NEW ORLEANS TO VENICE, LOUISIANA

# EMPIRE FLOODGATE

PERIODIC INSPECTION REPORT NO. 3

SUBJECT: New Orleans to Venice, Louisiana (Hurricane Protection); Reach B-1 -  
Tropical Bend to Fort Jackson, Empire Floodgate, Periodic Inspection  
Report No. 3, 29 July 1981

REVISION	DATE	DESCRIPTION	BY
NEW ORLEANS TO VENICE, LA.			
HURRICANE PROTECTION REACH B-1			
EMPIRE FLOODGATE			
PERIODIC INSPECTION			
<b>LOCATION OF INSTRUMENTATION</b>			
U.S. ARMY ENGINEER DISTRICT, NEW ORLEANS			
CORPS OF ENGINEERS			
SHEET OF SHEET		FILE NO H-4-27323

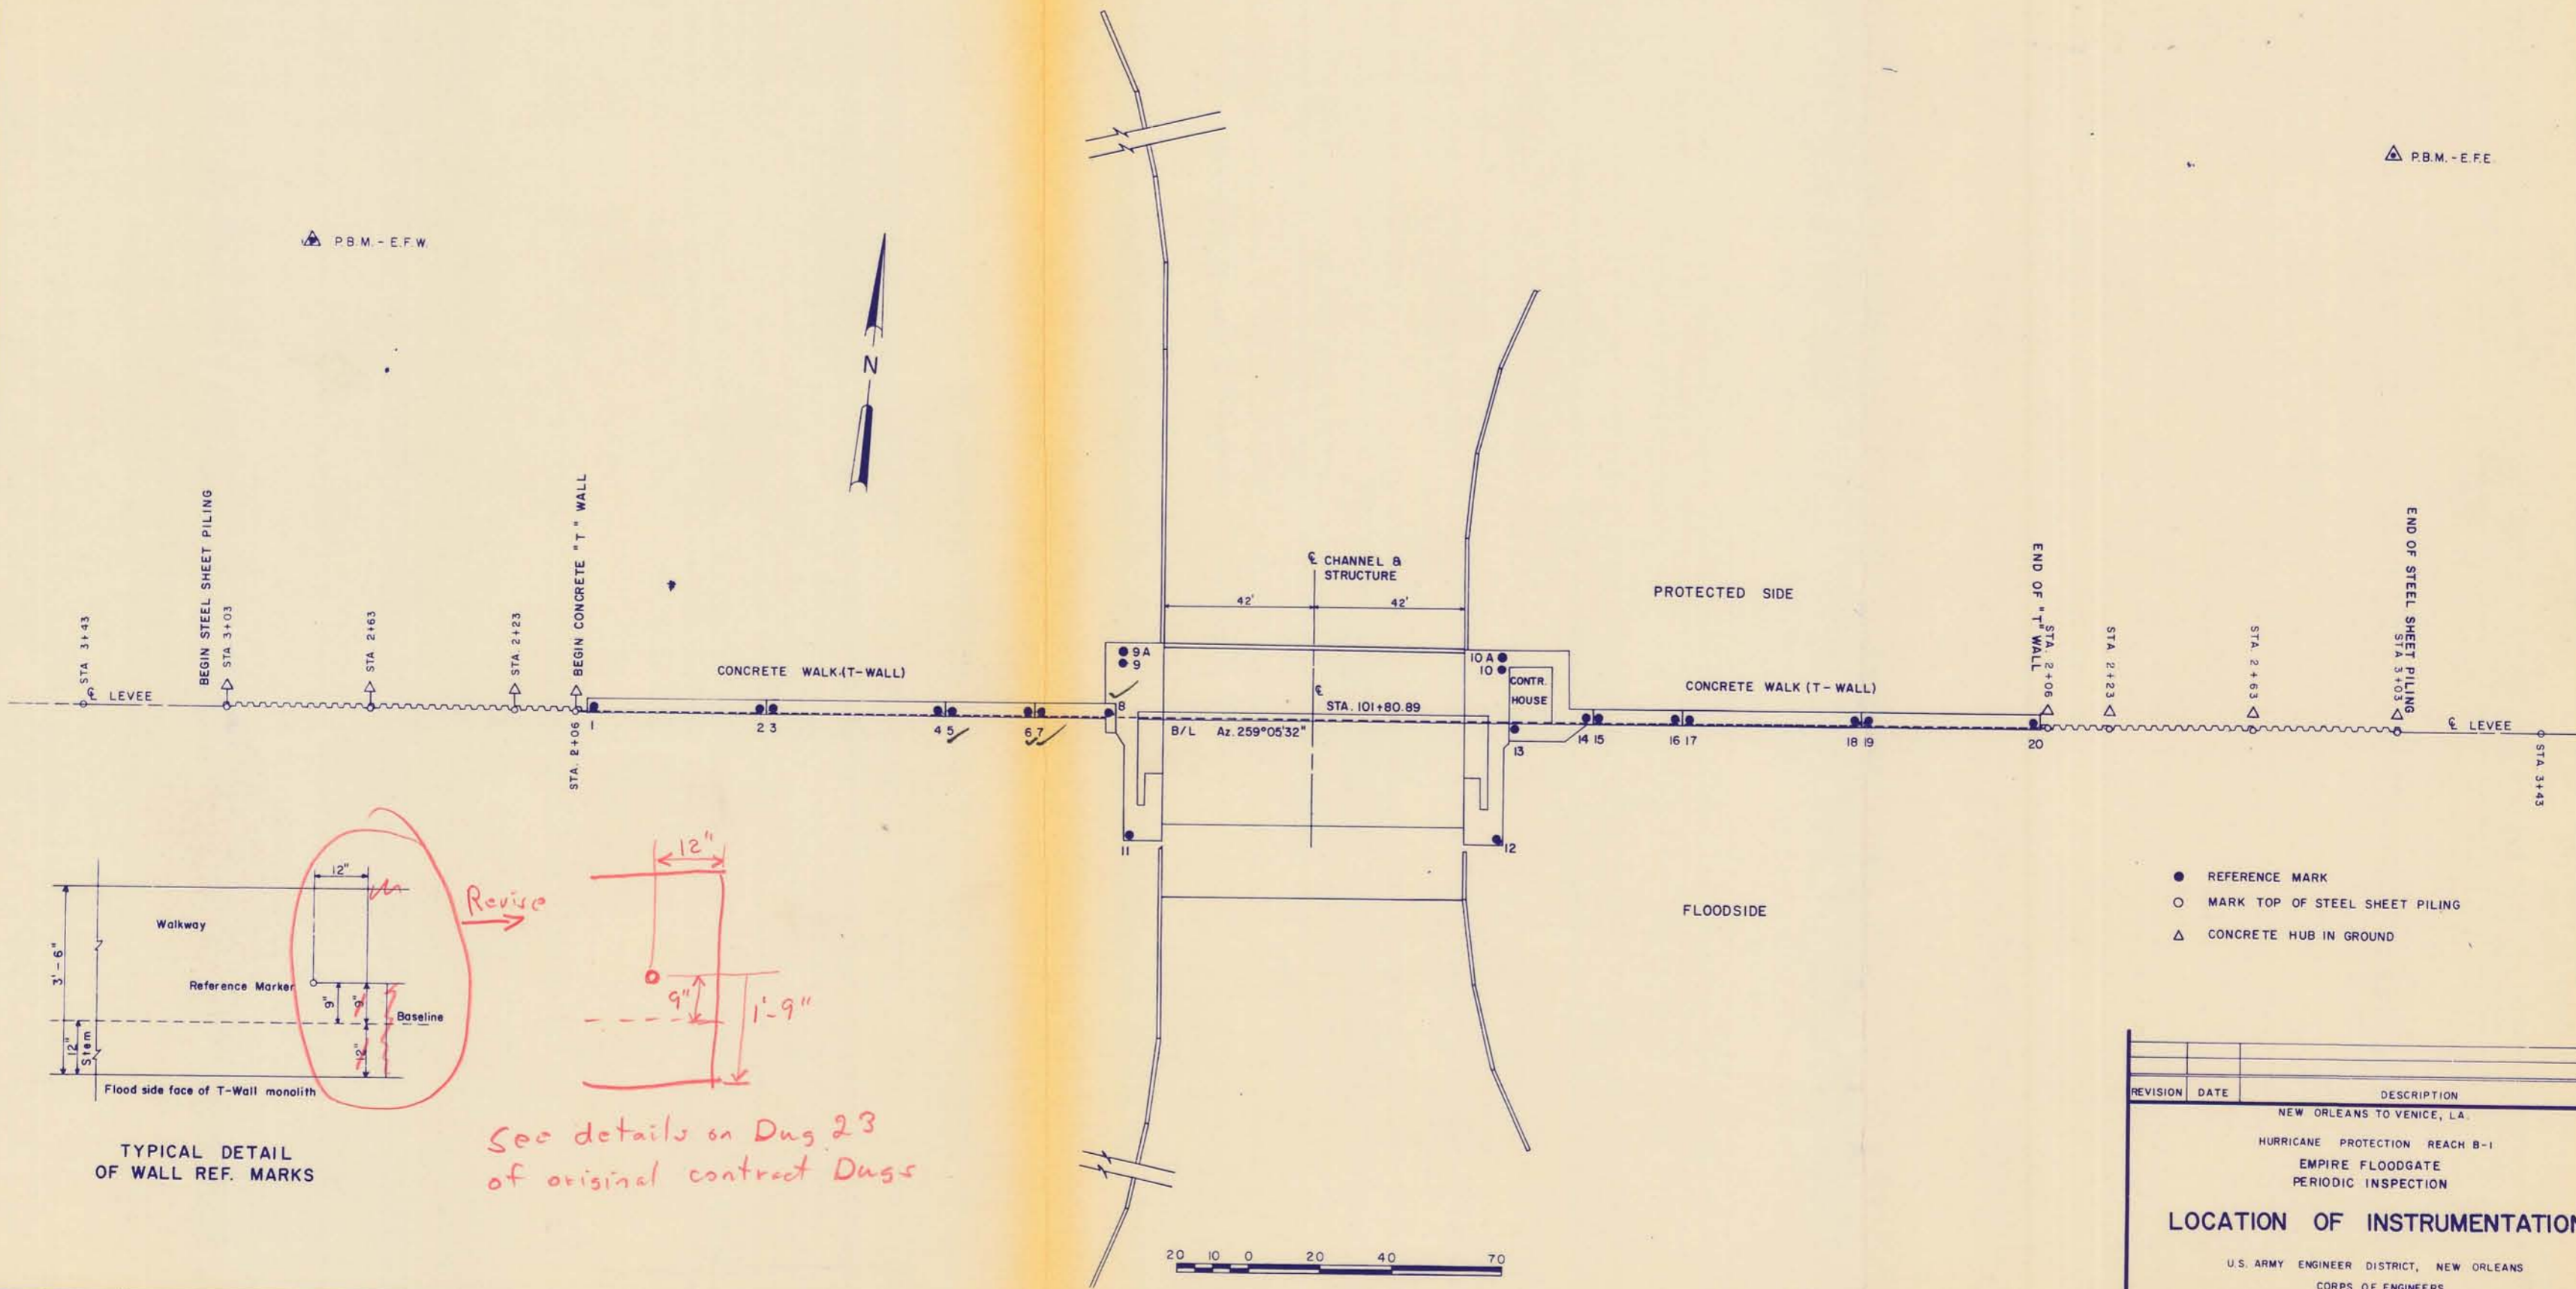
b. Para 2-01. The second sentence of the paragraph implies that Plate I-1 is a location map. However, Plate I-1 presents the location of instrumentation devices for this project. This discrepancy should be reconciled.

*Revise* →

*See details on Dug 23 of original contract Dugs*

b. Para. 2-01. Concur. Refer to Incl 3.

i. Plates I-1, I-3 and I-4 are being revised by drafting personnel. These plates will be issued to your office upon completion. The details noted on Plates I-6 and I-7 are anomalous obstructions picked up during the scour survey. Usually these obstructions are trash on the channel bottom.

NEW ORLEANS TO VENICE, LA.  
 HURRICANE PROTECTION REACH B-1  
 PERIODIC INSPECTION  
 EMPIRE FLOODGATE  
 ALINEMENT AND SETTLEMENT  
 REFERENCE MARKS - TABULATIONS  
 U.S. ARMY ENGINEER DISTRICT, NEW ORLEANS  
 CORPS OF ENGINEERS  
 SHEET OF SHEET FILE NO. H-4-27323/

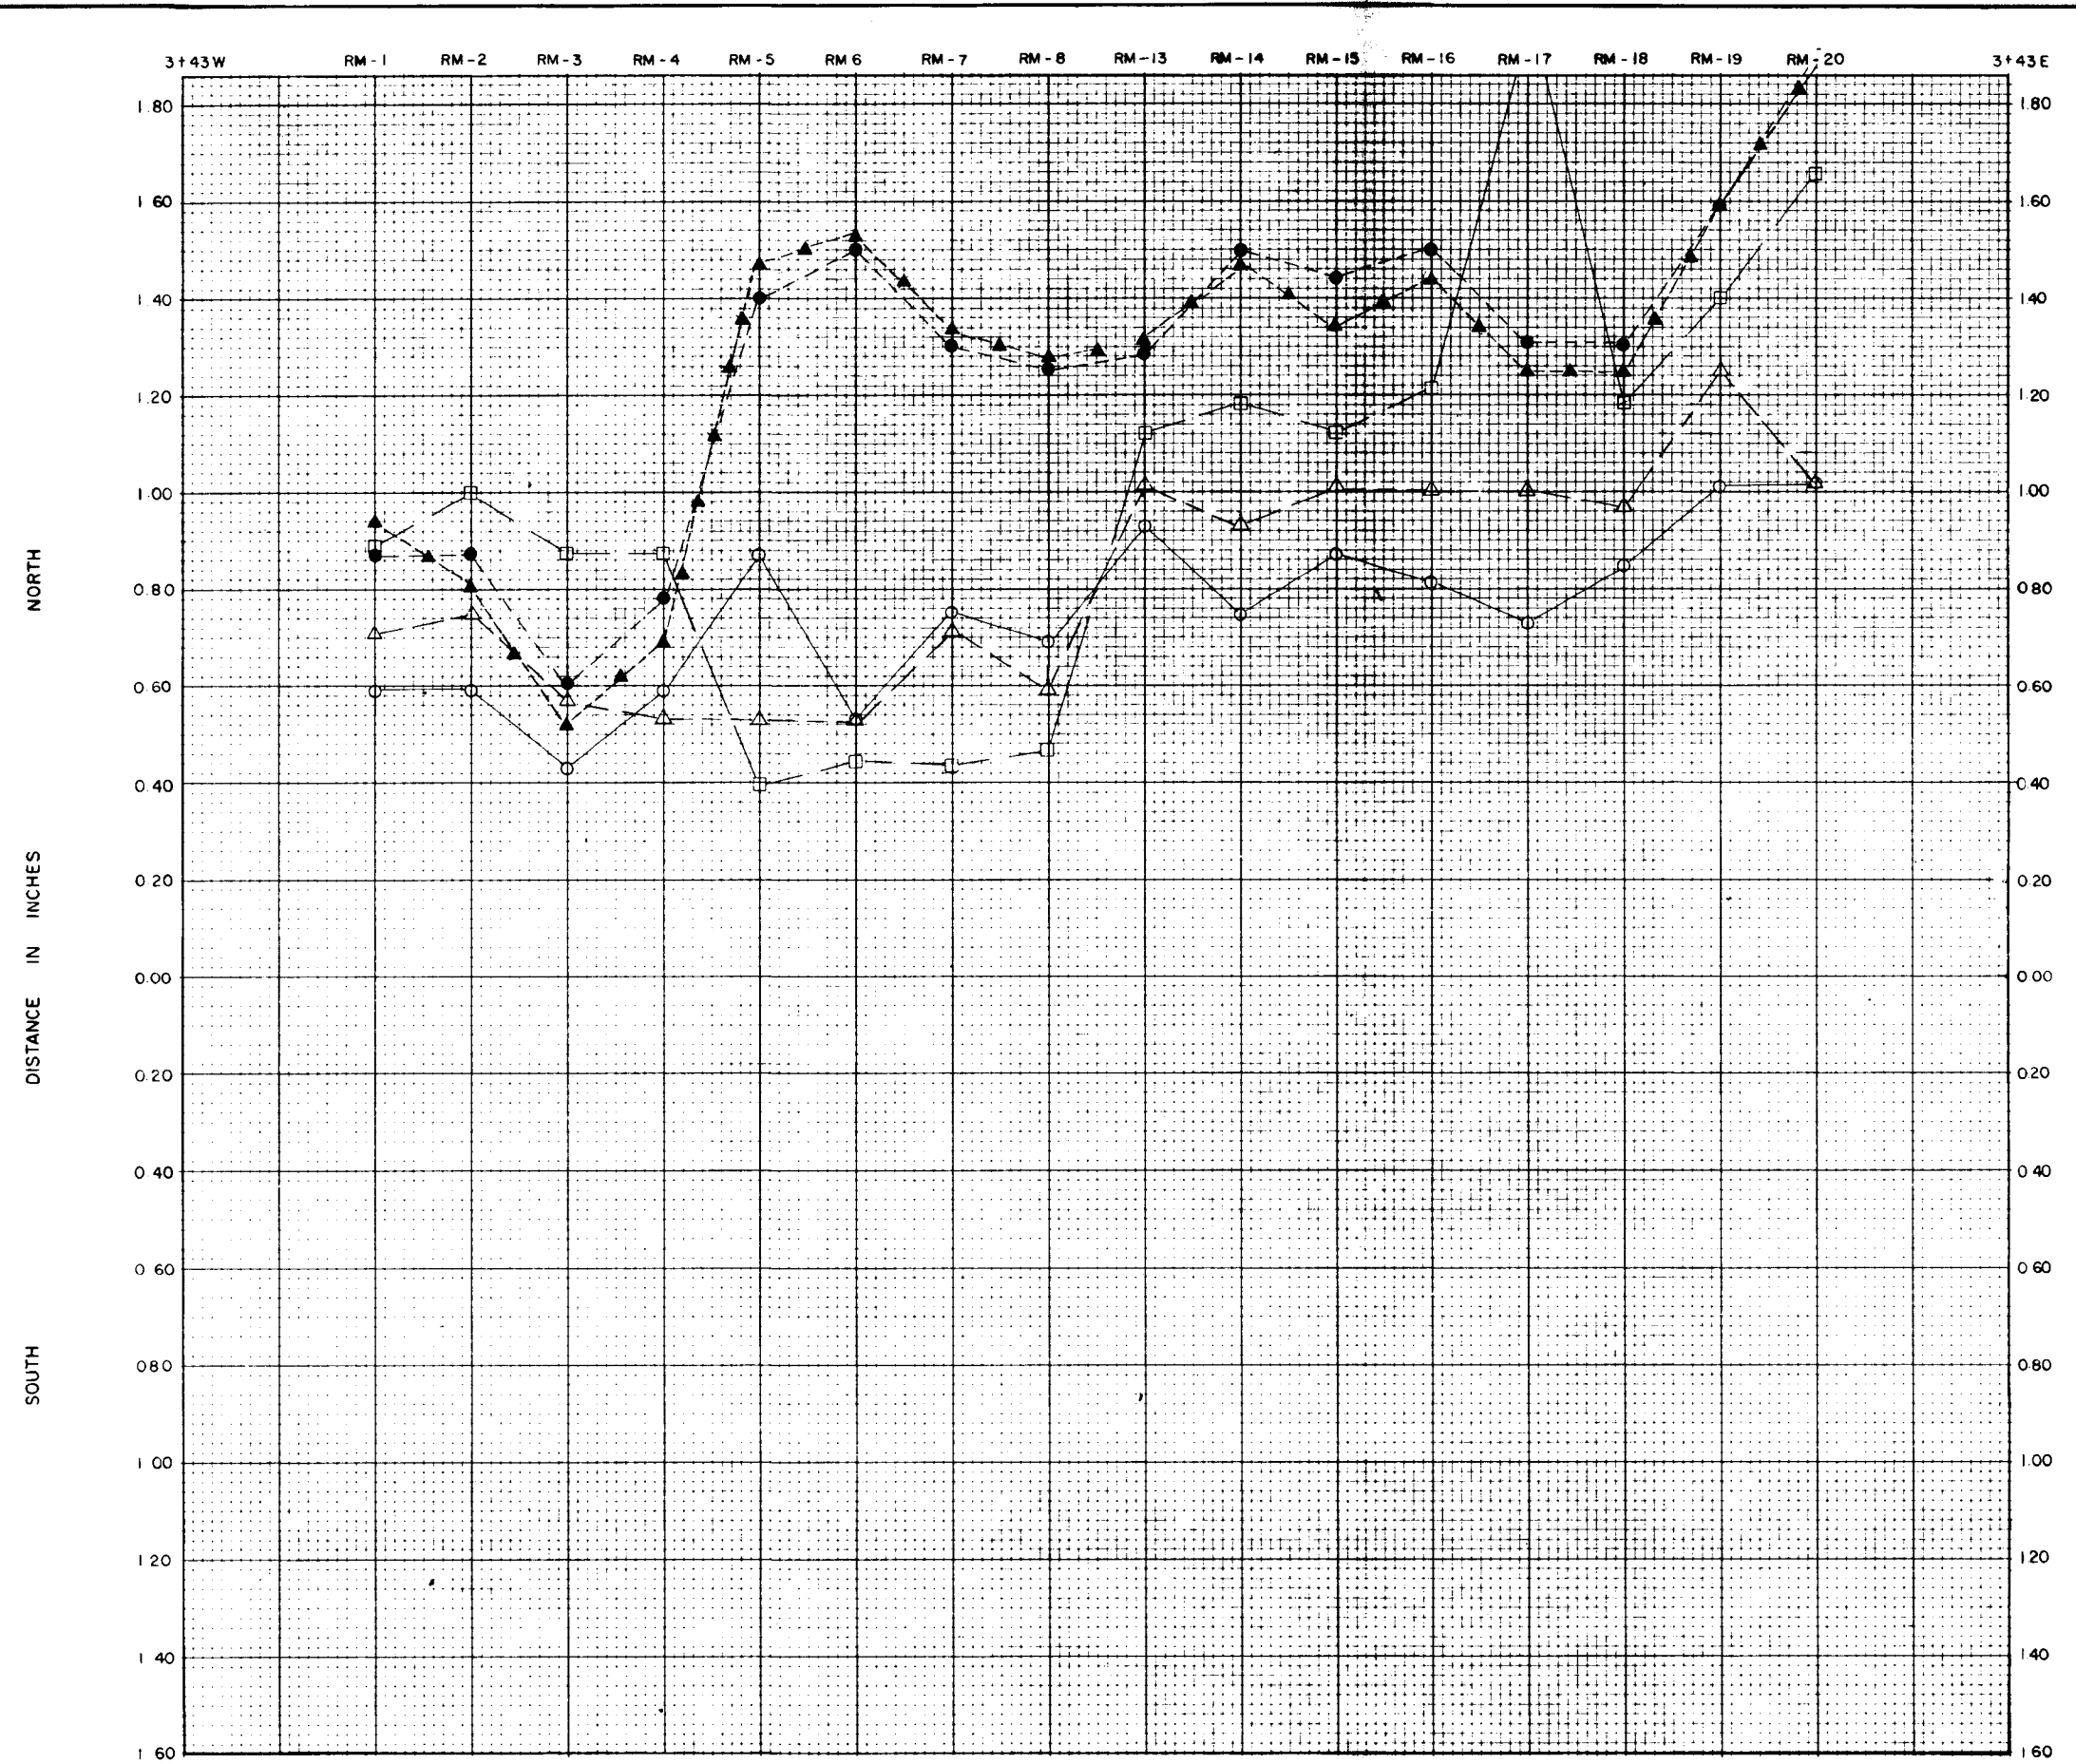
(1) Time-settlement plots similar to those shown for the T-wall reference mark data shown on Plates I-3 and I-4 should also be prepared for the data from the sheetpile I-wall settlement reference marks. These plots should be included in the inspection report.

(2) In light of the continued and significant settlement of the I-walls, T-walls, and structure, and to aid in evaluation of the settlement data, a profile of settlement from Sta 3+03E to Sta 3+03W (including the structure settlement data) should be prepared and presented in the report. This plate should be similar to Plate I-2A except that settlement would be plotted on the vertical axis.

(3) See comment in para 1d above. In evaluating the T-wall settlement data, you should indicate whether the observed settlement is considered reasonable when compared to settlement predicted in design.

(1) Time settlement plots are presently being prepared for the data from the sheetpile I-wall settlement reference marks. These plots will be issued to your office upon completion by our drafting personnel.

(2) Concur. A profile of settlement from Sta. 3+03E to Sta. 3+03W (including the structure settlement data) will be prepared and issued to your office.

(3) Concur. The observed settlement of 4 inches is considered reasonable compared to the predicted design settlement of 6 inches for the T-wall data.
